DM/25/01083/FPA - Land To The South Of Cockhouse Lane, Ushaw Moor, DH7 7PN

Erection of 158 homes with associated landscaping and infrastructure.

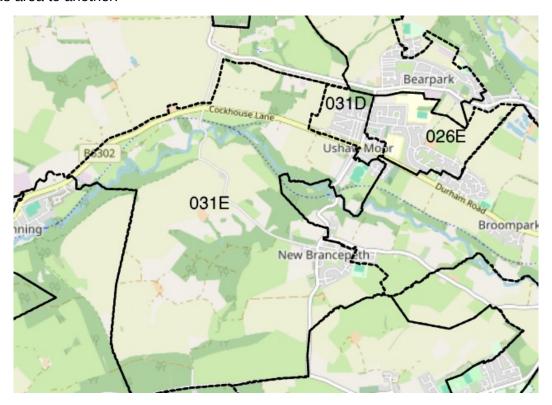
The Trust welcomes the proposal to provide a shared-use cycling and walking link to the east of the site (one of the routes shown in green below), connecting to the back of Station Road, as this will help to provide useful links to the centre of Ushaw Moor and to the Deerness Valley Railway Path.

The pedestrian path linking northwards (shown in green above) should have the tight corners removed and be designed for cycle use as well. This will shorten the route that cyclists would have to navigate to exit the development northwards from houses in the south-east of the development.

The Trust considers that the permeability of the site for active travel is lacking. In order to access the connection to the east of the site, people living in dwellings on the western edge have quite a detour (shown in yellow) to access it. This is made worse by the gradient of the site. The Trust considers that a pedestrian/cycle link should be provided through the site along the axis shown in purple above, which would be relatively level and would shorten the distances people would have to walk or cycle. This would also improve access to bus stops.
